PROPOSED CHANGE ORDER

PROJECT: Montgomery High School

PCO #: 25

DESCRIPTION OF THE PROPOSED CHANGE: Added Landscaping Project

1 SITE DEMOLITION PLAN
1" = 30'-0"

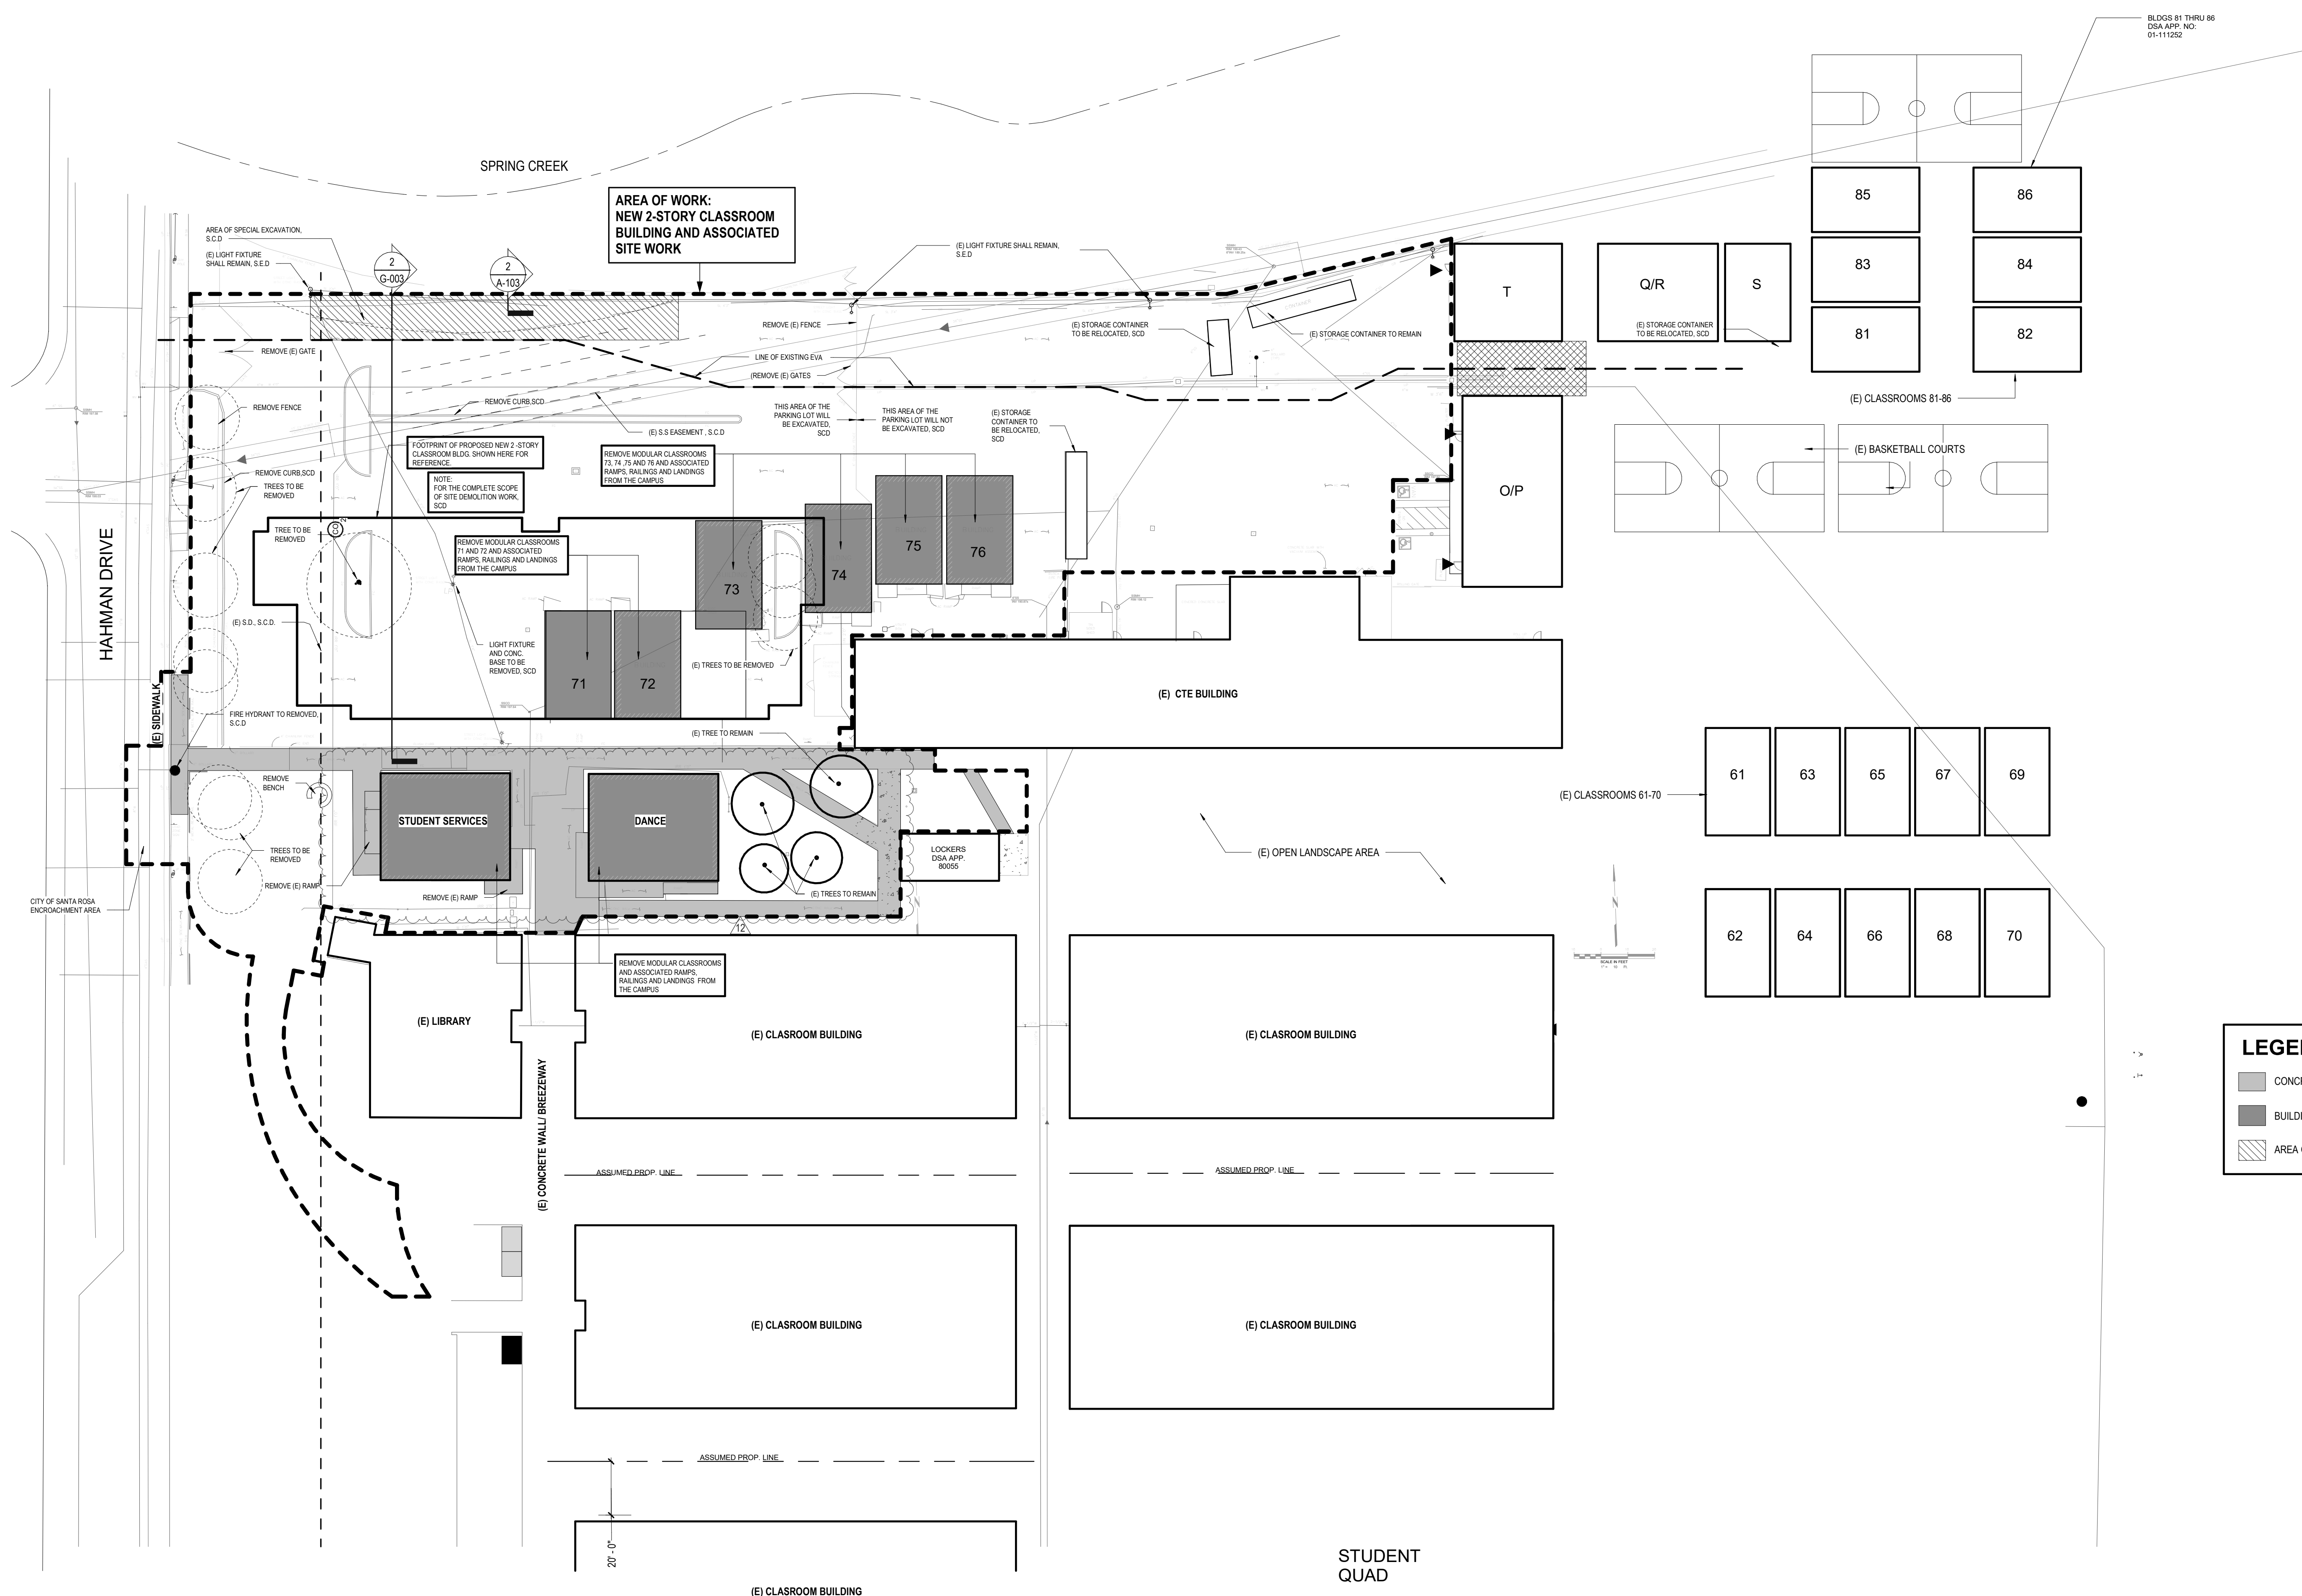
A-102	Updated site demo plan to indicate removal of portable classrooms and paving
A-103	Updated site plan to indicate area of new work south of new classroom building and new gates south of existing library building

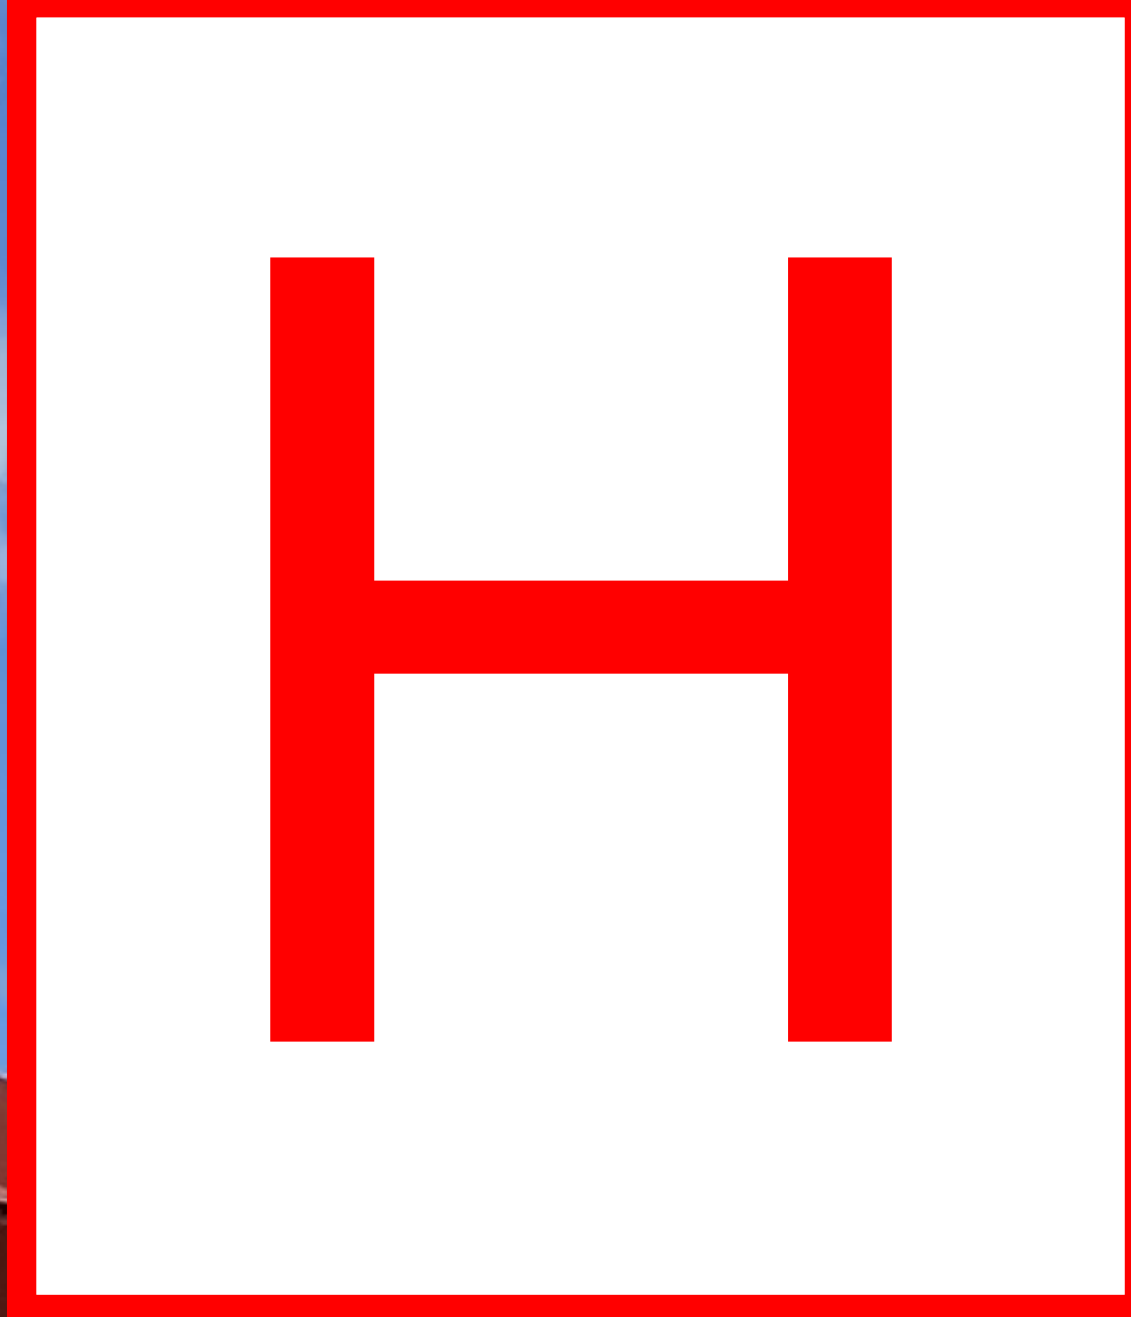
Install same style of gate as is currently installed only 8' tall with 1" black Non-climb chain link fencing. (Refer to Sheets B, C, D, & E)
